**ADDENDUM NO. 3**

**PROJECT: 5524**  
**February 5, 2024**

**BAKERSFIELD CITY SCHOOL DISTRICT  
MUNSEY ELEMENTARY SCHOOL  
HVAC REPLACEMENT  
3801 BRAVE AVENUE  
BAKERSFIELD, CA 93309**

**DSA APP# 03-122489**

Sheet No: **E2.20**

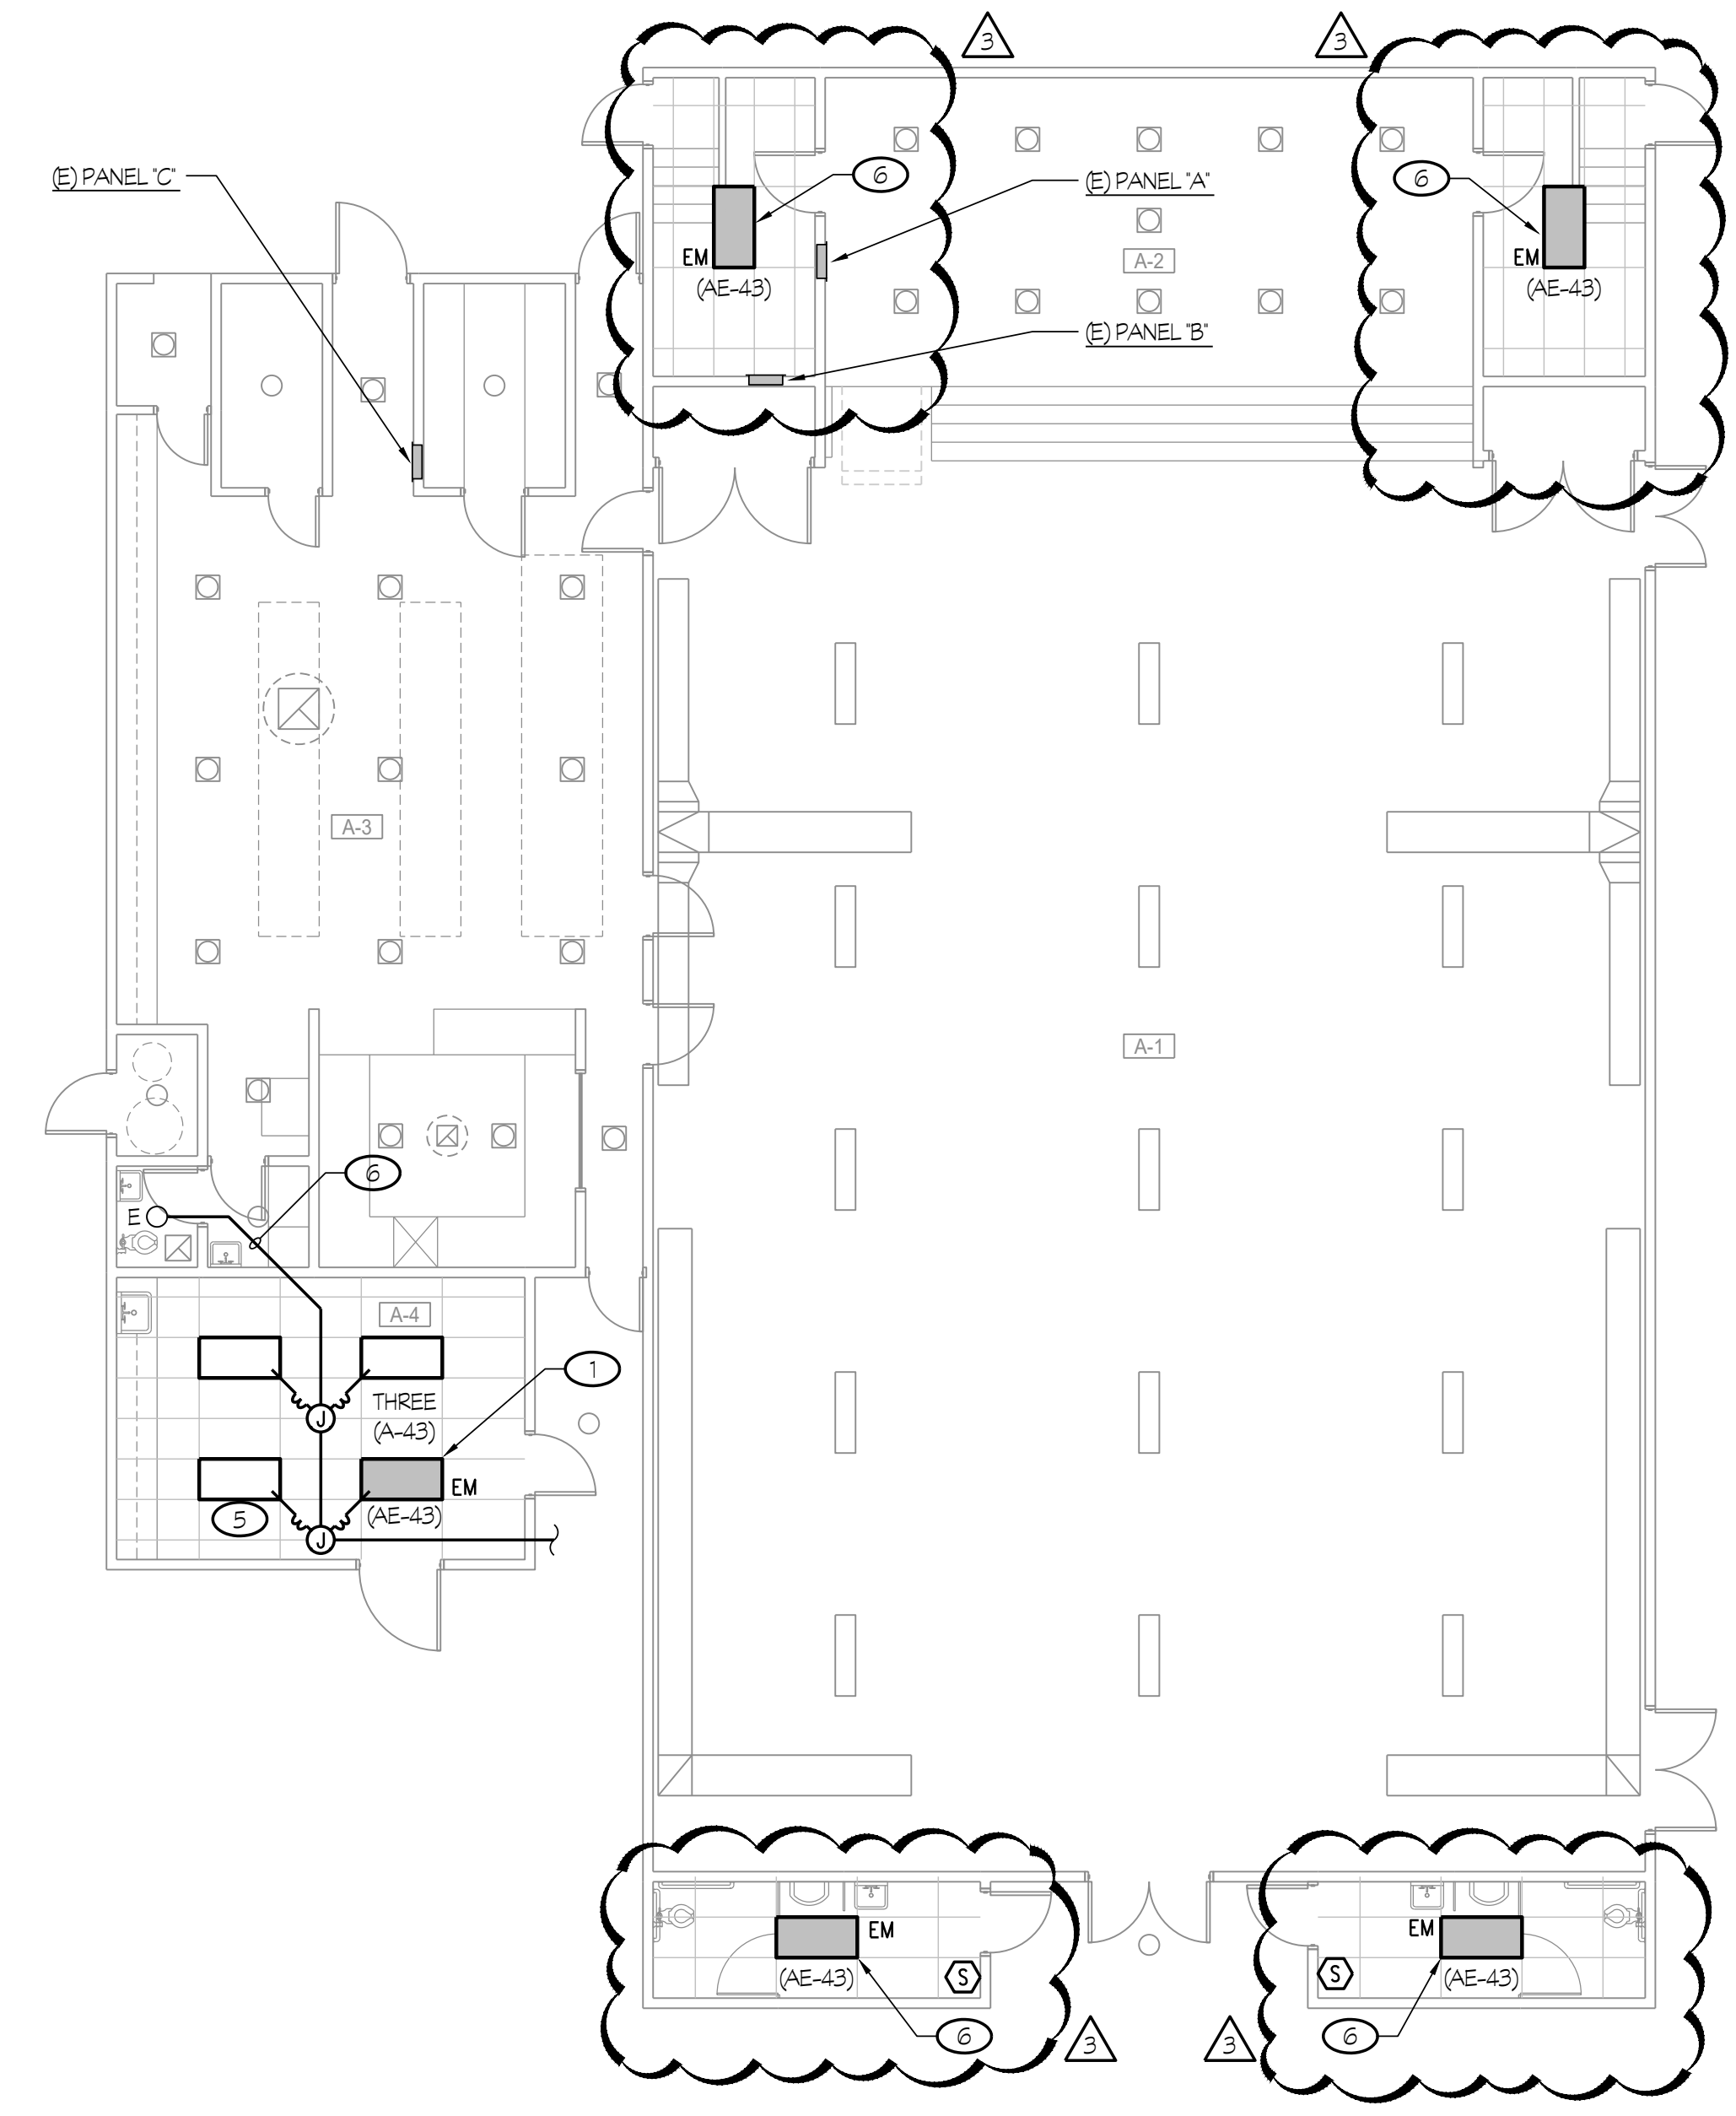
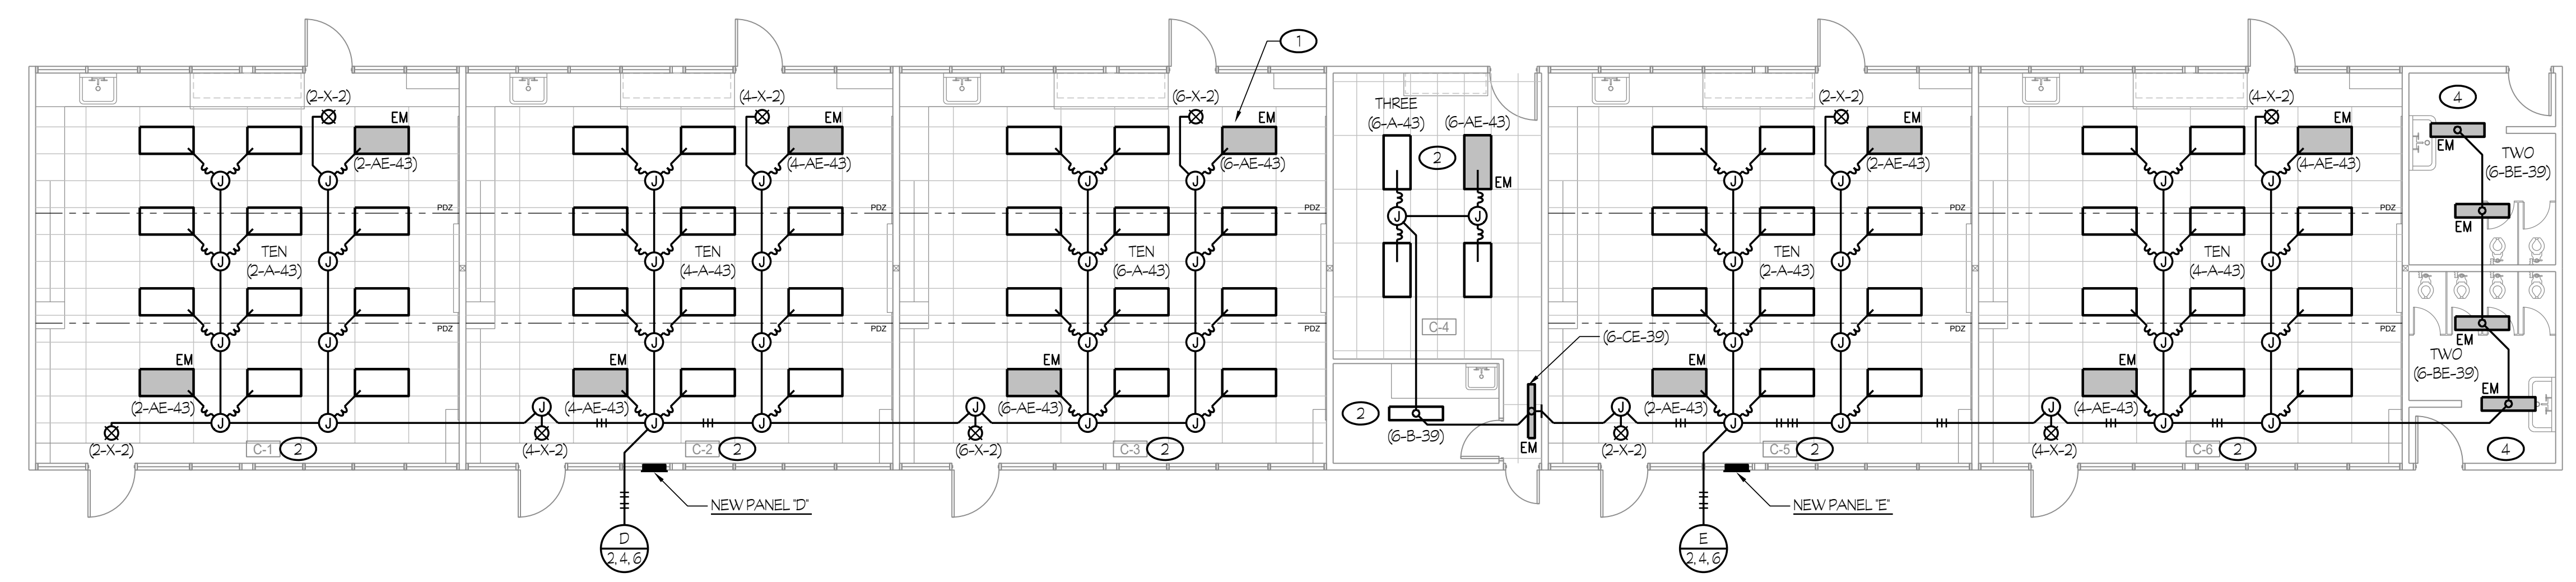
3.10 Building A reflected ceiling plans on sheets A6.10 and A6.20 have been revised to indicate the removal of the existing ceiling in the rooms on each side of the Stage room A-2 and new 2'X4' suspended acoustical tile ceiling system. Building A lighting plan E2.20 was coordinated with the architectural drawings.
